**DOWNTOWN POMPANO  
PHASE I INFRASTRUCTURE**

**ADDENDUM TO RFP 02-2026  
REQUEST FOR PROPOSAL**

## ADDENDUM #1

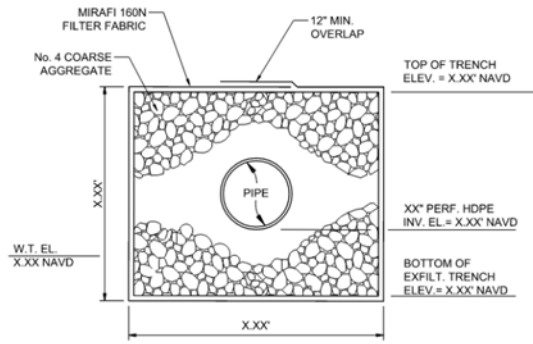
1. QUESTION: Please provide clarification regarding whether the earthwork and grading for the area highlighted in yellow is intended to be included in our proposal for this project:

RESPONSE: Yes, the area outlined above in yellow is included in this scope and is included in the civil drawings (See Sheets 107 & 108).
